BLINCOE FARMS

IDAHO DEPARTMENT OF WATER RESOURCES
ADJUDICATION CLAIM PROFILE REPORT
(REGIONAL)

MEMORANDUM

Subject: DISCUSSION OF RECOMMENDATIONS

PLACE OF USE OVERLAP REVIEW

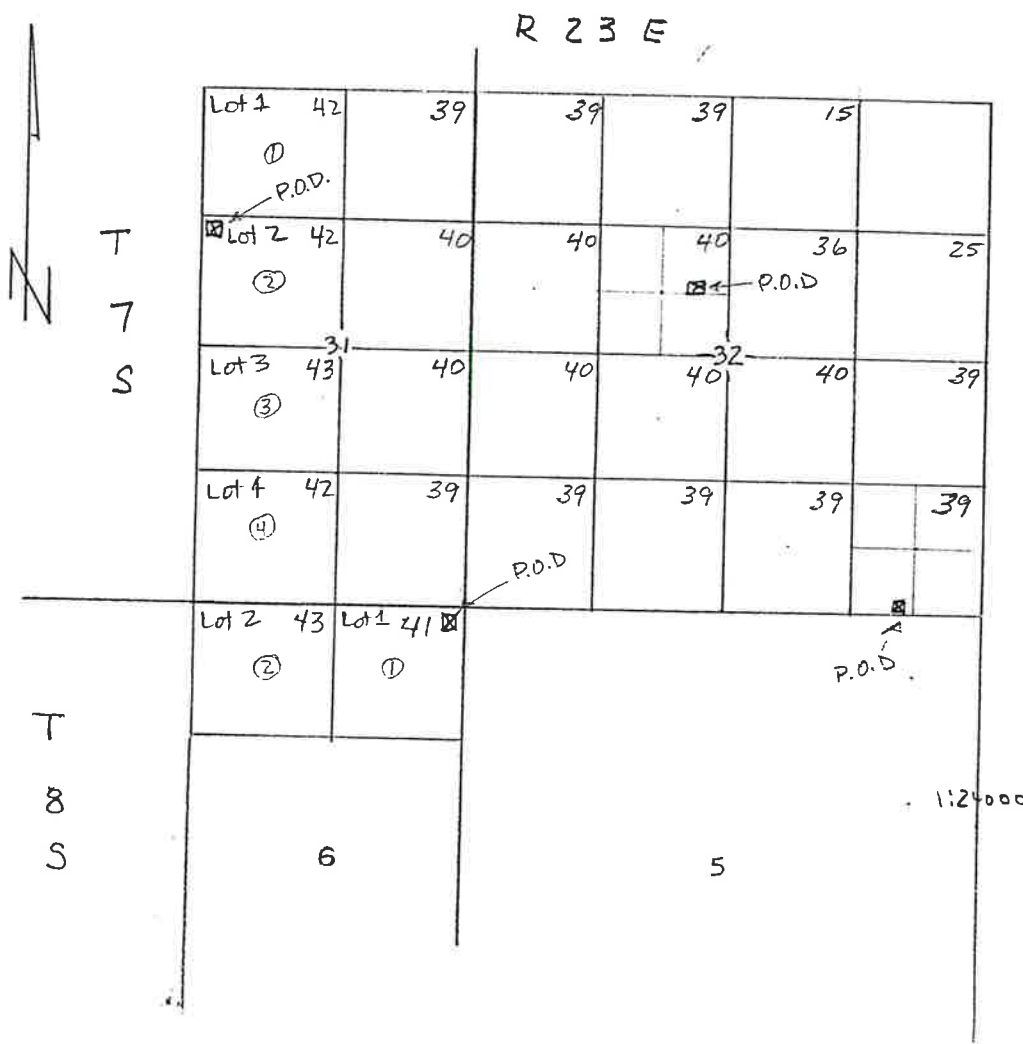
See Original maps & field notes in
A36-02230B

Recommend AGES - Blincoe Farms
- Permissible Place of Use
